(GRADING & DRAINAGE PLAN)

A PROPOSED PLAN
FOR
D & B U-SELL-IT (EAST)
MENAU BLVD. N.E.
ALBUQUERQUE, NEW MEXICO
OCTOBER, 2005
(02-20-06)

TRAFFIC CIRCULATION LAYOUT

A PROPOSED PLAN FOR D & B U-SELL-IT (EAST) MENAUL BLVD. N.E. ALBUQUERQUE, NEW MEXICO

ENGINEER'S CERTIFICATION
(GRADING & DRAINAGE PLAN)

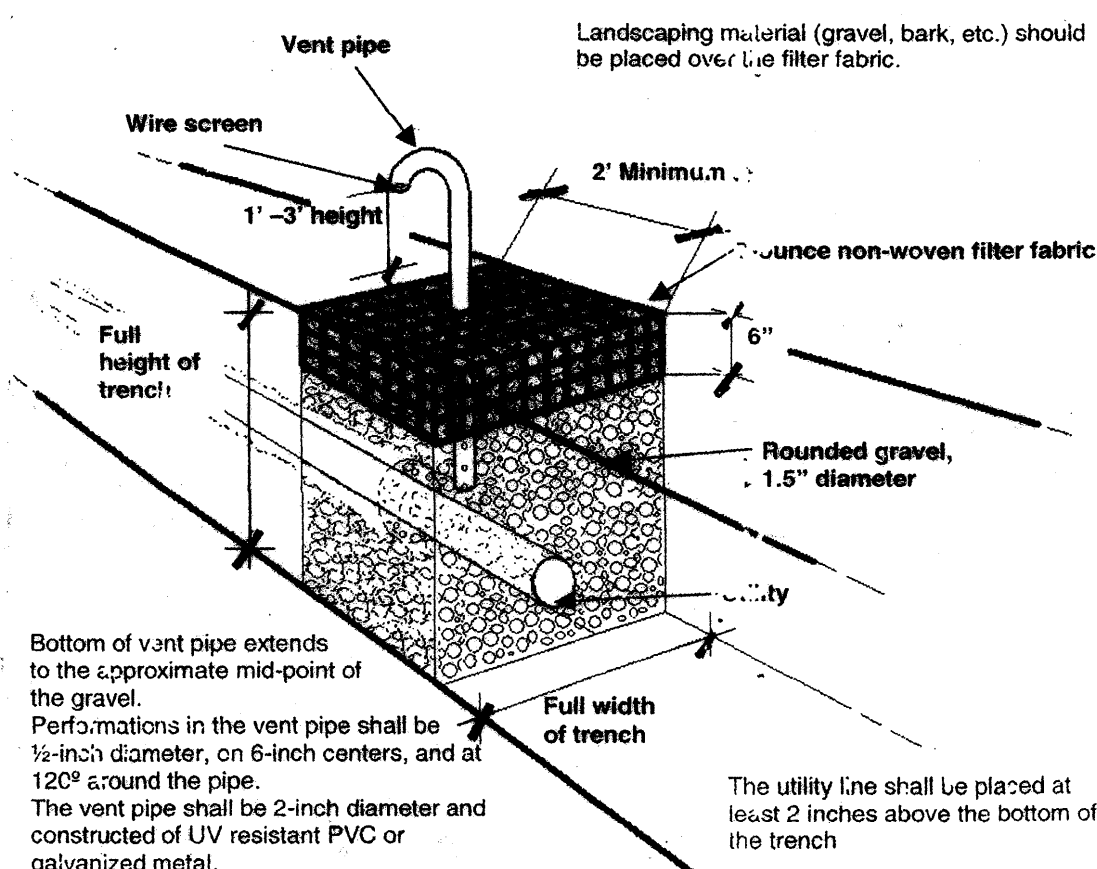
10-12-05 NOTE: ITEM 1 & 2. HEREIN HAVE BEEN SATISFIED AS OF THIS DATE. NOTE 10-12-05:
a.) THE PROPOSED SPEED-BUMP ALONG THE WEST BOUNDARY LINE FOR THE EXISTING PAVED DRIVE HAS NOT BEEN PROVIDED AT THIS TIME, (SATISFIED).
b.) AT THIS TIME THERE IS A REMAINING PORTION TO BE PAVED ADJACENT TO THE TRAIL AND ENCLOSURE, (SATISFIED).

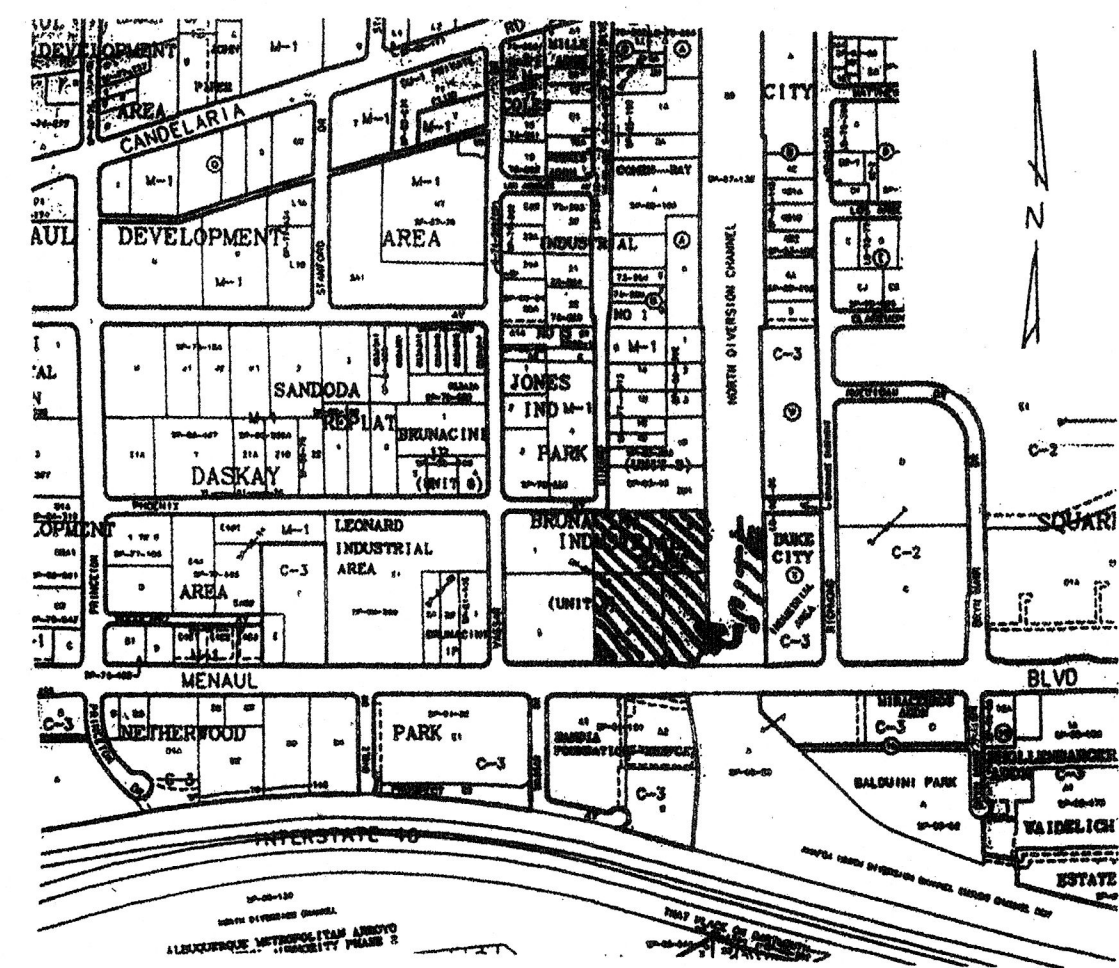
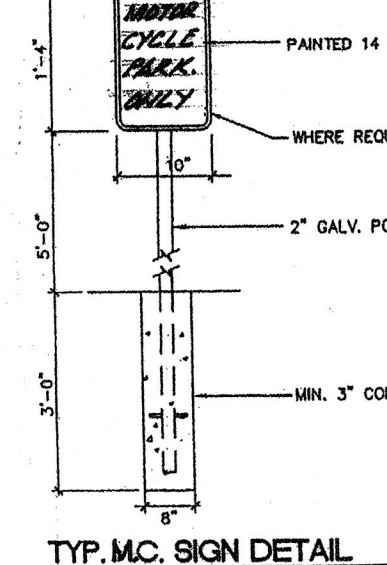
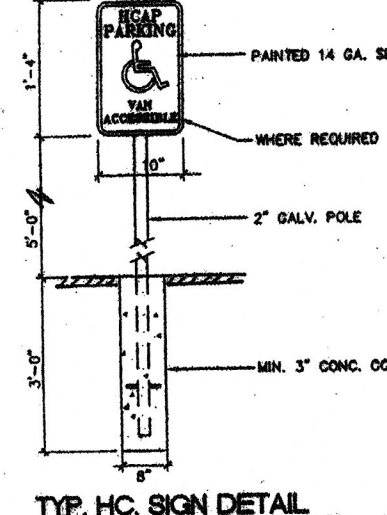
Note: Provide a "Knox" Box @ Gate for Emergency Access

- PED PATHWAY
- CLARIFY EXTENTS OF PARK
- UTILITY MAP (LEG. ABIS)
- LEGEND
- WILL AREA BE RESTRICTED?
- LEGAS DESCRIPTION
